Pyrmont Peninsula

Finalisation of sub-precinct master plans and rezoning

July 2022

Figure 12 – Proposed podium height (RL 35.3)

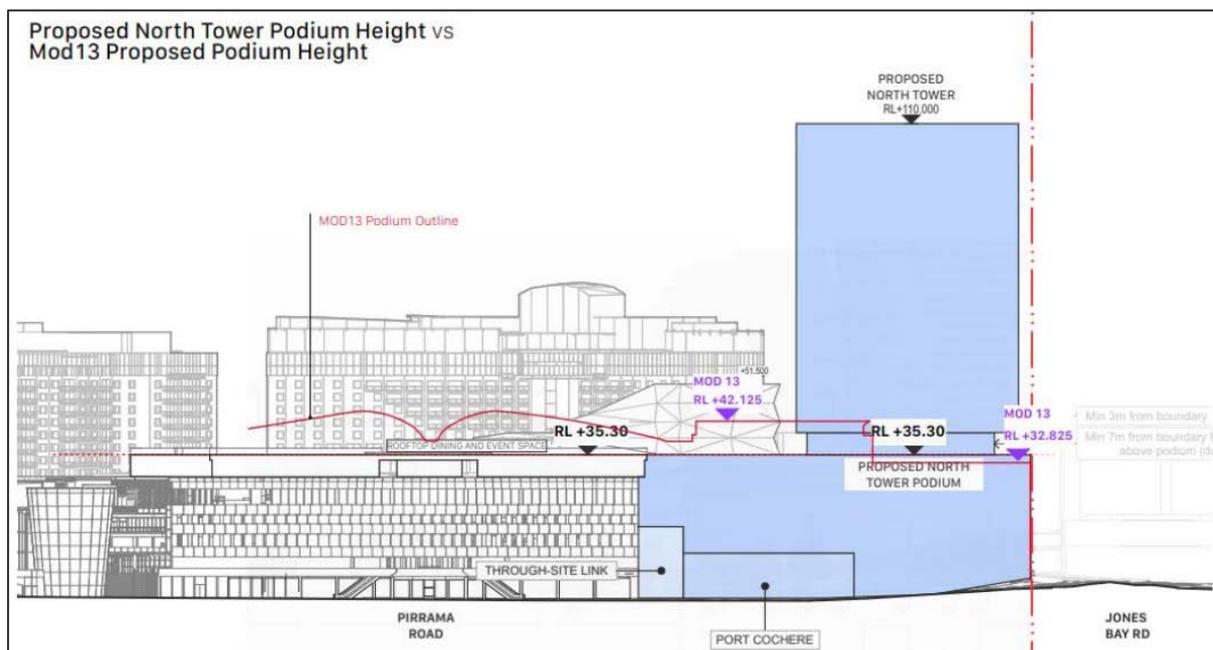
The Star's street wall height and tower setbacks were proposed to match the Star's master plan on the basis that the street wall height of RL 32.8 and up to RL 35.3 reflects an earlier development assessment done by the Department. Specifically, this assessment related to MP08_0098-Mod-13, where the previously proposed 237m tower at the same site proposed a street wall height at RL 32.8 around Jones Bay Road and up to RL 42.125 on Pirrama Road (refer Figure 12).

It was concluded as part of that modification assessment that the proposed podium height was acceptable despite the overall tower proposal (237 m) not being supported.

Figure 13 – The six-star hotel floor plate and setbacks

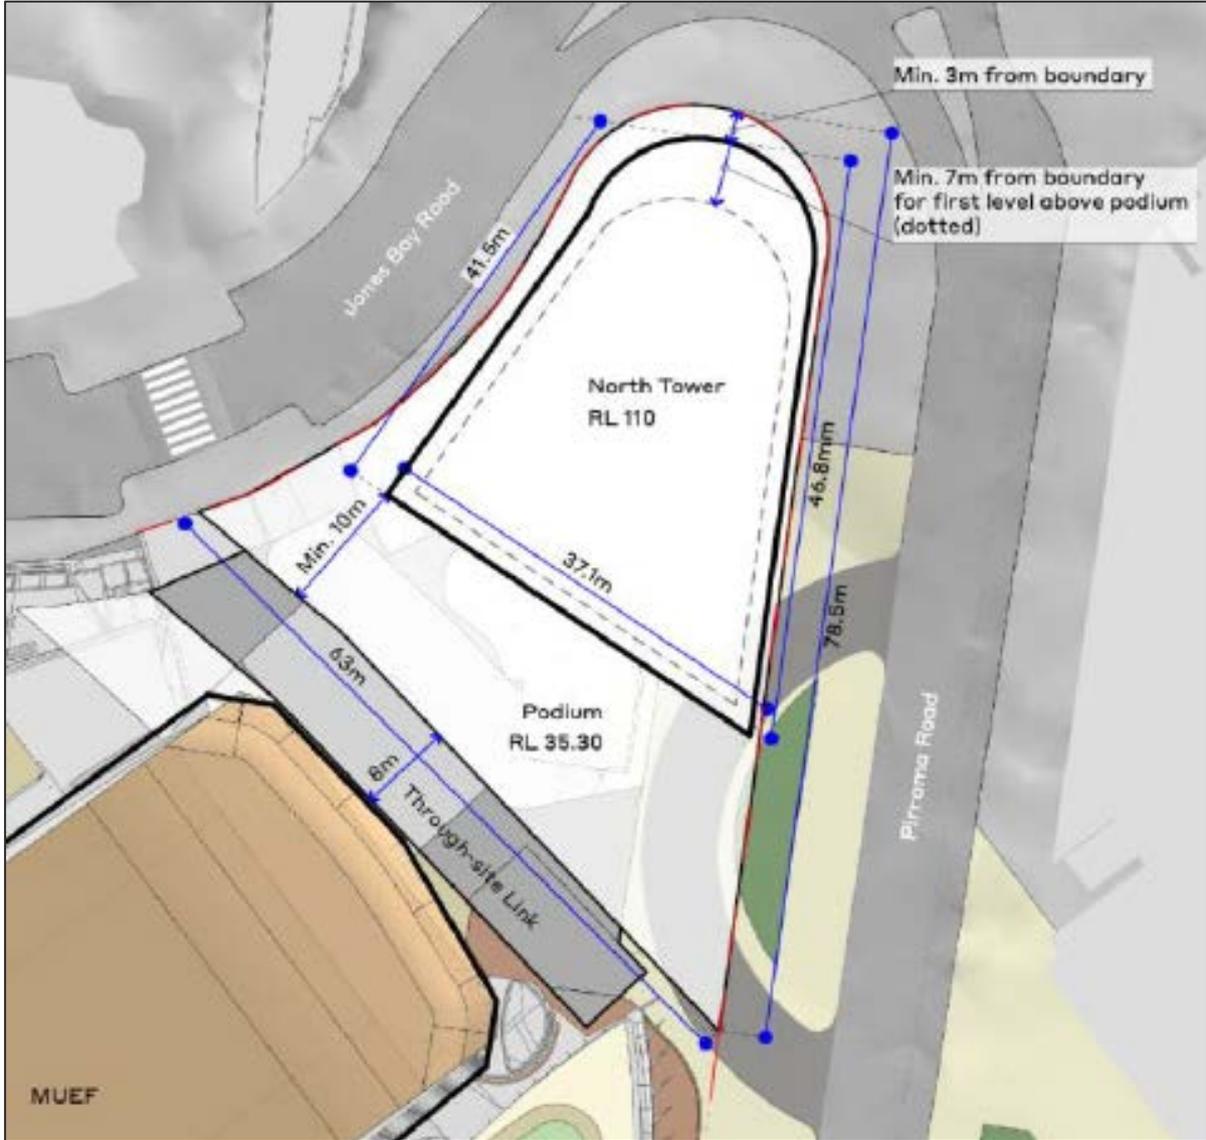
The Star's key site master plan proposed setbacks for the tower above the podium of between 0.5 m (to Pirrama Road) and up to 3 m (to Jones Bay Road), with a larger 7 m setback to the first level above the podium only to address the corner of Jones Bay and Pirrama Roads (refer Figure 13).

The Star's submitted wind assessment raised concern with the wind environment and that for the tower setbacks proposed at an average of 3m and below (refer Figure 13), wind mitigation measures such as awnings, would be needed at ground level to ensure a suitable wind environment at street level.

The Department considers awnings to mitigate wind impacts at ground level may mean the loss of existing street trees. Consequently, the potential to locate the tower in a way that would increase the setbacks of the tower above the podium level was investigated (see Figure 14). This analysis was based on consideration of Council's approach in Central Sydney where tall buildings are often required to provide tower setbacks of up to 8 m to mitigate adverse wind conditions on the street below.

Figure 14 – Exhibited hotel floor plate and setbacks

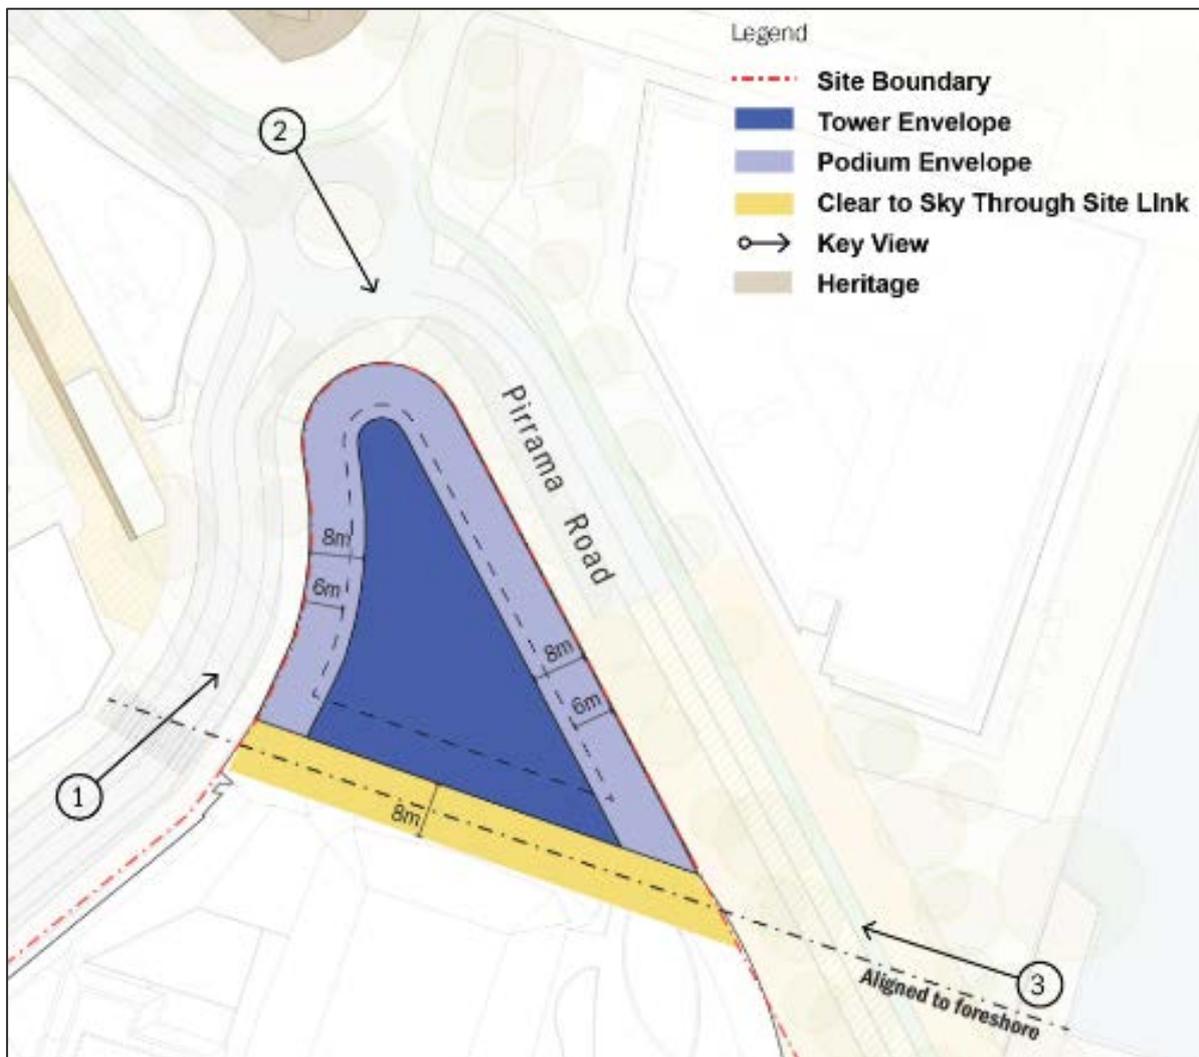
The Department exhibited tower setbacks above the street wall height at 6-10m, with an average of 8m (refer Figure 14). This range was to break up the bulk of the development, mitigate against adverse wind impacts that may occur at ground level because of a tall tower nearby, and provide an equivalent floor space outcome albeit in a modified floor plan.

Figure 20 – Recommended setbacks for UTS IRC

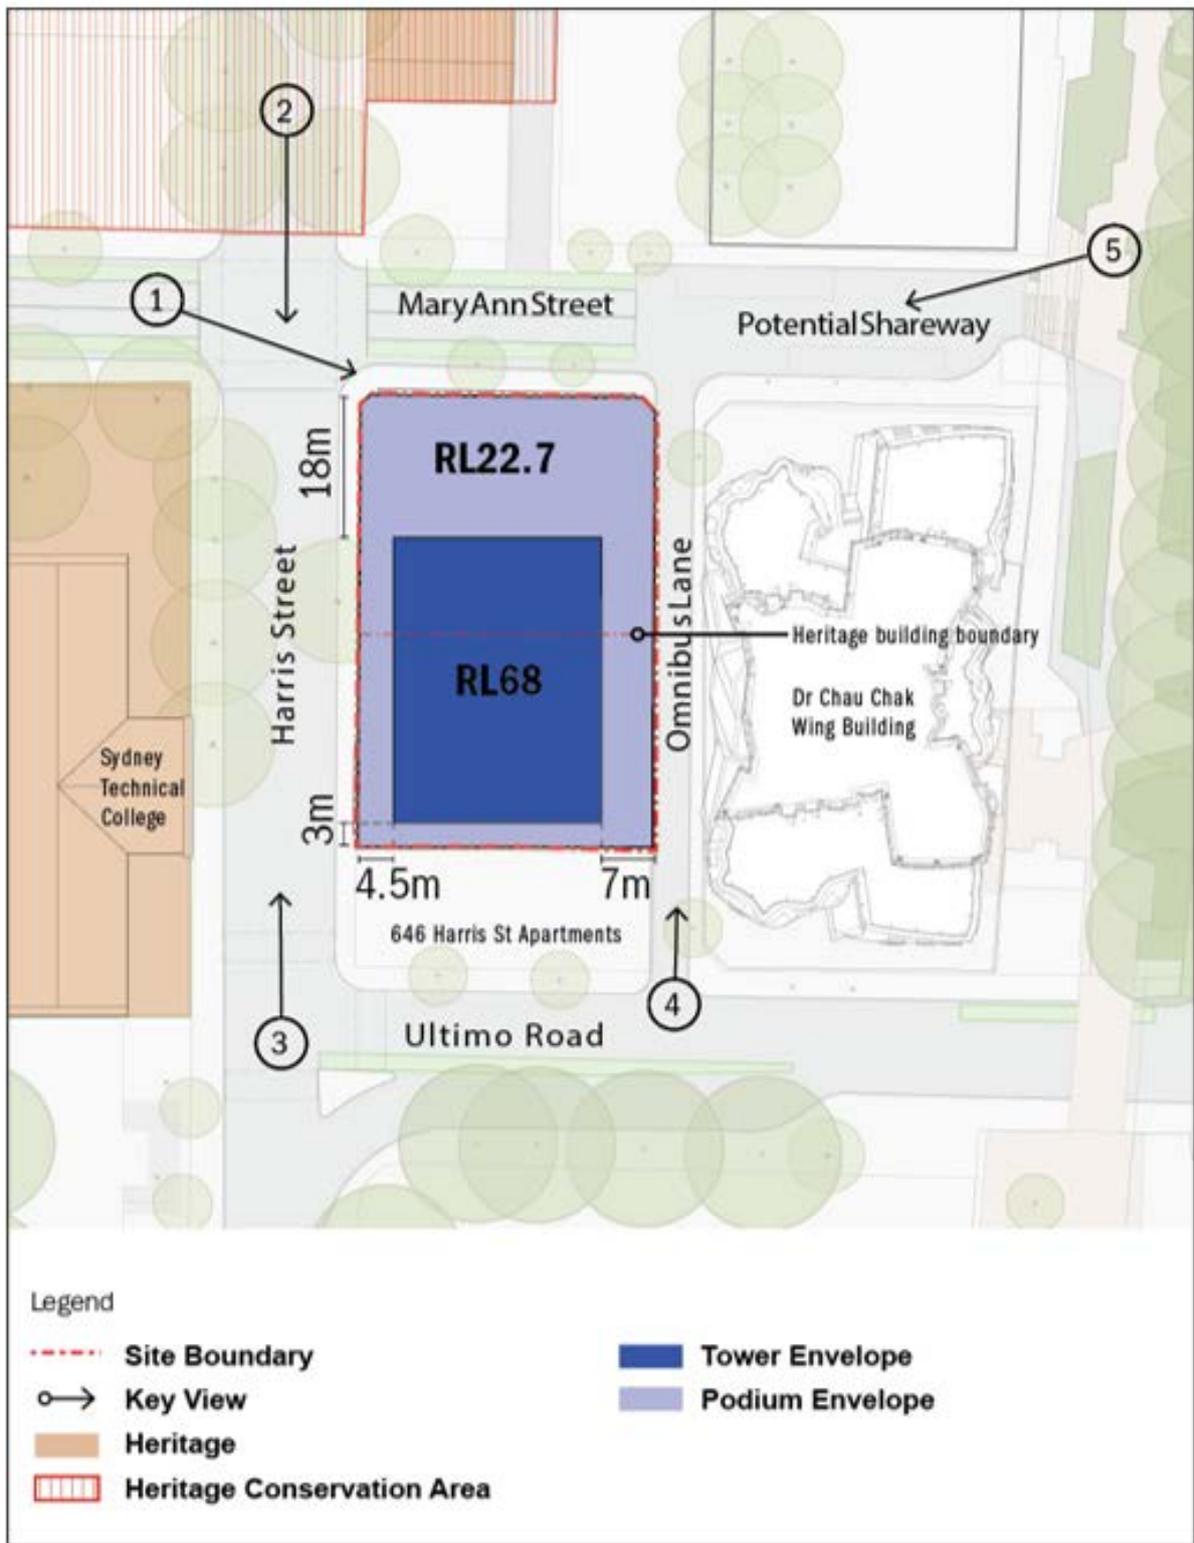
The Department also proposed a larger setback to Harris Street of 6m compared to the UTS key site master plan setback of 3m. In its submission on the Department's draft design guidelines, UTS proposed an alternate 4.5m setback to Harris Street on the basis it enables a feasible development, the delivery of UTS' 'precinct heart' open space concept, solar amenity to neighbouring residents and an appropriate setting of the building in the streetscape (see Figure 20 and Figure 21 below).

It should be noted the depiction of the 'Precinct Heart' in Figure 20 is based on UTS' key site master plan and proposal to demolish the rear third of the NCR building. As noted earlier in this section, the Department does not support the full demolition of the rear third and has required UTS investigate retention of some or all of the floor area in a 'Heritage Investigation Zone' in Design Guidelines.

The revised 4.5m setback to Harris Street is acceptable noting it represents an appropriate outcome for the context and setting of a new tower on the site and would support the intent of the Department's larger setback to ensure the NCR building 'reads independently' from the street and amenity to nearby residents. The setbacks also provide an optimal relationship between new and existing development on nearby sites (see setbacks depicted in Figure 18).

Figure 28 – Draft Pyrmont Peninsula Special Infrastructure Contribution Area

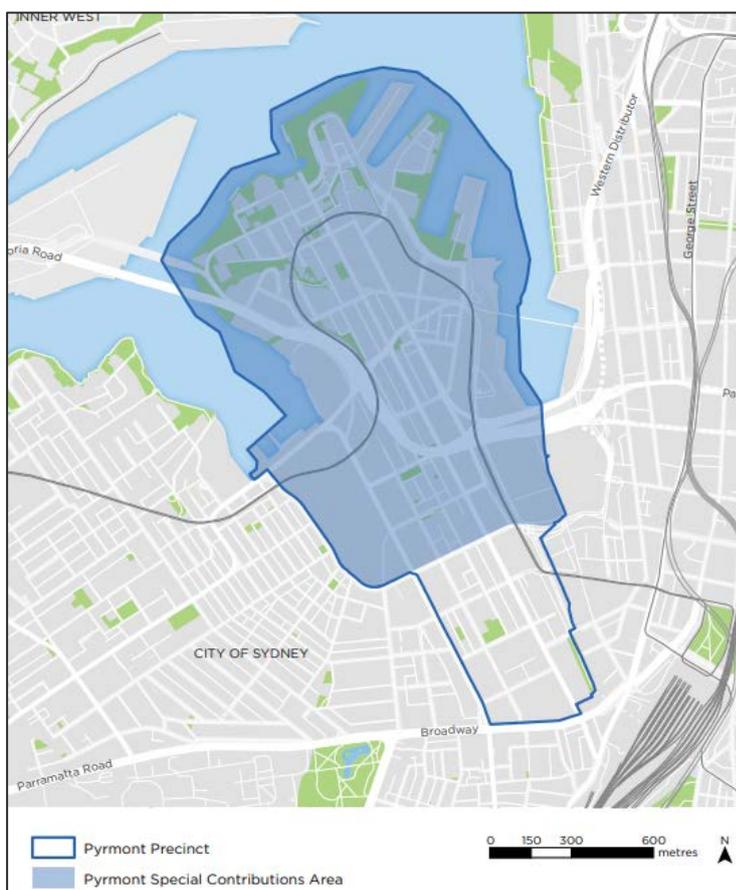
In relation to where and how it would apply, the Department exhibited the Pyrmont Special Contributions Area (SCA) (refer Figure 28) showing where the SIC would apply to all new residential and non-residential development.

To address concerns regarding where the SIC would apply, and to ensure only development benefiting from uplift due to improved access to the Pymont metro station, a revised SCA has been established. The revised area is reduced in size and more closely reflects the areas containing the sites capable of change identified in the PPPS (refer to Figure 29).
